# Access Compliance Report

## Public Rights-of-Way

### (Curb Ramps)

Intersection ID: 10100	Main Street: ASHLEY_RD	Cross Street: FREEDOM_DR	Location: S
ADA ID: B848FD70EEF3	Ramp Type: Perp	Initial Pass/Fail: Fail	Overall Compliance: No
		Severity Score: 8.75	
Codes/Mitigation Info/Possible Solution		Field Measurements/Component Compliance

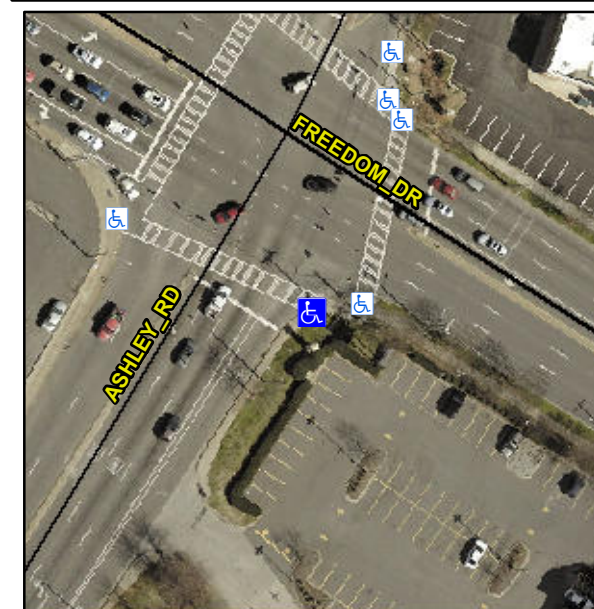
**Not Found, R304.5.1**

Compliance	Description	Data	Compliance	Description	Data
N/A	Ramp Length (in)	46.0	Yes	Ramp Slope (%)	6.6
No	Ramp Width (in)	47.5	Yes	Ramp XSlope (%)	1.0
N/A	Flare Type LT	N/A	N/A	Flare Type RT	N/A
N/A	Flare Slope LT (%)	N/A	N/A	Flare Slope RT (%)	N/A
N/A	Flare Traversable LT?	N/A	N/A	Flare Traversable RT?	N/A
N/A	Landing Length (in)	N/A	N/A	DWS Provided?	N/A
N/A	Landing Width (in)	N/A	N/A	DWS Contrast?	N/A
N/A	Landing Slope (%)	N/A	N/A	DWS Length (in)	N/A
N/A	Landing X Slope (%)	N/A	N/A	DWS Full Width?	N/A
N/A	Landing Curb? (Y/N)	N/A	N/A	DWS Offset (in)	N/A
N/A	Shared Landing?	N/A			
N/A	Gutter Ponding?	Yes	N/A	Gutter Slope (%)	N/A
N/A	Gutter Lip Ht (in)	N/A	N/A	Gutter X Slope (%)	N/A
N/A	Painted X Walk1?	Yes	N/A	Painted X Walk2?	N/A
	X Walk 1 Direction	To NW		X Walk 2 Direction	N/A
N/A	X Walk 1 Width (in)	111.0	N/A	X Walk 2 Width (in)	N/A
	X Walk 1 Slope (%)	4.1		X Walk 2 Slope (%)	N/A
	X Walk 1 X Slope (%)	4.3		X Walk 2 X Slope (%)	N/A

**Remove & Replace Entire Ramp.**
